BRIAN TAYLOR
STATE FIRE MARSHAL

RE: Fire Protection of Steel Column within 3-Hour Firewall (UL V438) and Compliance with 2018 North Carolina Building Code (NCBC) Table 721.1(1), Item #1-7.3

This letter responds to your request for a formal interpretation from the Office of State Fire Marshal (OSFM) dated March 10, 2025 and received by OSFM the same day. Your request seeks clarification on two questions, as follows:

FLOOR PLAN

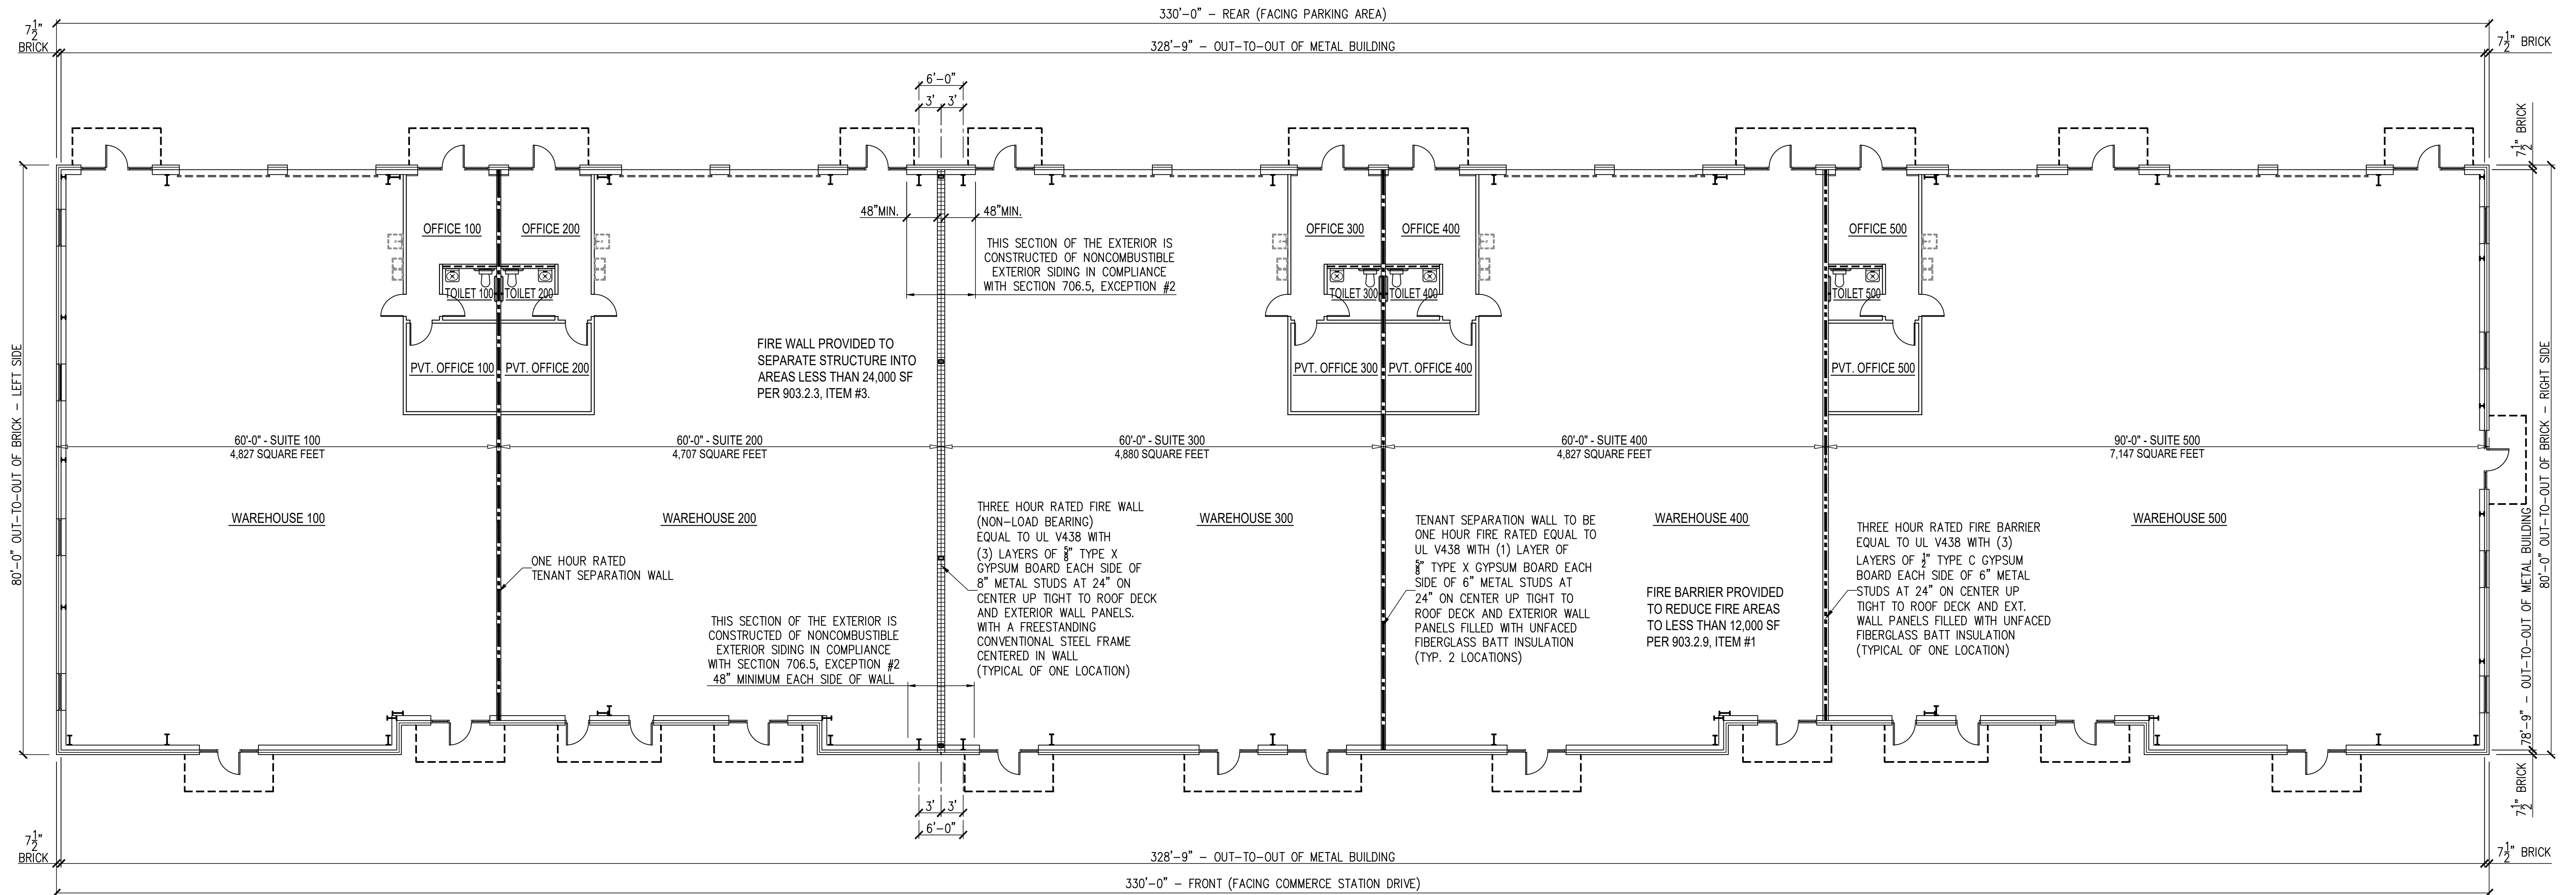
This floor plan has a three hour fire wall equal to UL V438 with (3) layers of 5/8" type x gypsum board each side of 8" metal studs at 24" oc up tight to the metal roof panels and tight to the metal exterior wall panels with a free standing conventional steel frame centered in the wall. This wall is not load bearing and designed by our structural engineer to allow collapse of the structure on either side without collapse of the wall under fire conditions. Refer to the attached floor plan in PDF for reference.

Our question for your interpretation is does the three layers of 5/8" gypsum board specified in V438 and totaling 1-7/8" total thickness protect the concealed structural steel frame inside the wall in accordance with the prescriptive requirements in Table 721.1 (1), Item #1-7.3 or does the steel frame require additional and/or alternative protective measures?

1. The 3-hour firewall designed per UL V438 does not meet the prescriptive requirements of NCBC Table 721.1(1), Item #1-7.3, which specifies a steel column encased with three layers of 5/8-inch Type X gypsum wallboard, attached to 1-5/8-inch steel studs (No. 25 gauge) with specific screw sizes and spacing, and secured with wire ties for the middle layer. UL V438, as a proprietary tested wall assembly, uses a different configuration (e.g., variable stud sizes, number of drywall layers, and insulation) optimized for wall performance and is not listed in Table 721.1(1). Modifications to UL V438's framing, drywall, or connections are not permitted unless supported by an engineering judgment approved by code enforcement officials. The determination of fire resistance for UL V438, as a proprietary design, requires strict adherence to the tested assembly's specifications (e.g., stud size, number of drywall layers, insulation, and connections) as detailed in its UL listing. UL V438 complies with NCBC Section 703.3 as a tested assembly, providing a 3-hour fire-resistance rating for the wall when configured accordingly.

2. A concealed steel column within a UL V438 3-hour firewall requires individual fire protection (e.g., per Item #1-7.3 or other approved methods) on all sides for the full column height, including connections to other structural members, unless the building uses light-frame construction and the column is located entirely between the top and bottom plates of the wall assembly, as per NCBC Section 704.4.1, allowing the assembly's membrane protection, strictly adhering to UL V438's proprietary design (e.g., specified stud size, drywall layers, insulation, and connections), to provide the required 3-hour fire-resistance rating. In all other construction types, individual encasement on all sides for the full column height is required because UL V438 is a proprietary design for wall protection, not column protection.
